SERVICE LETTER

No. 530

Subject: Hydraulic Fluid Level Gauge "O" Ring Replacement

Models Affected: PA-31 and PA-31-300 Navajo

Hydraulic Fluid Level Gauge Assembly, P/N 43725-00

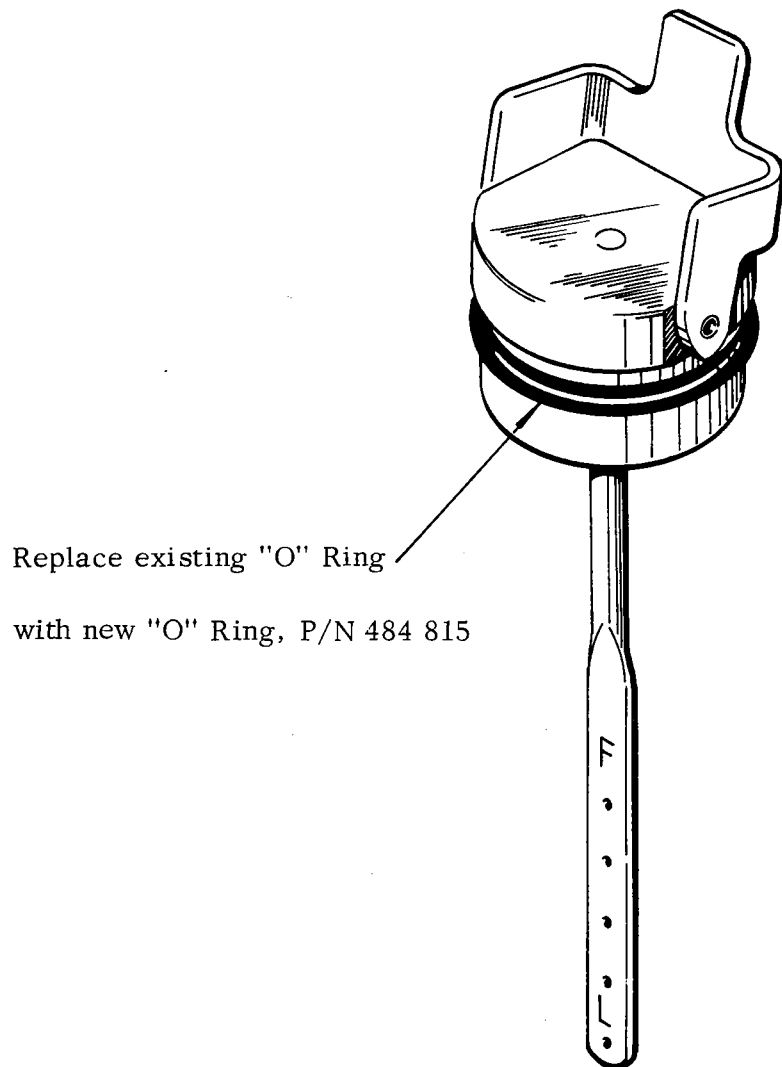
Purpose: To provide an improved "O" Ring seal for the hydraulic fluid level gauge assembly (part number 43725-00).

Instructions: Remove existing "O" Ring (part number 484 805) from hydraulic fluid level gauge assembly, and install "O" Ring part number 484 815 (see sketch on reverse side of this letter for details).

Material Required: One (1) each "O" Ring, Piper part number 484 815
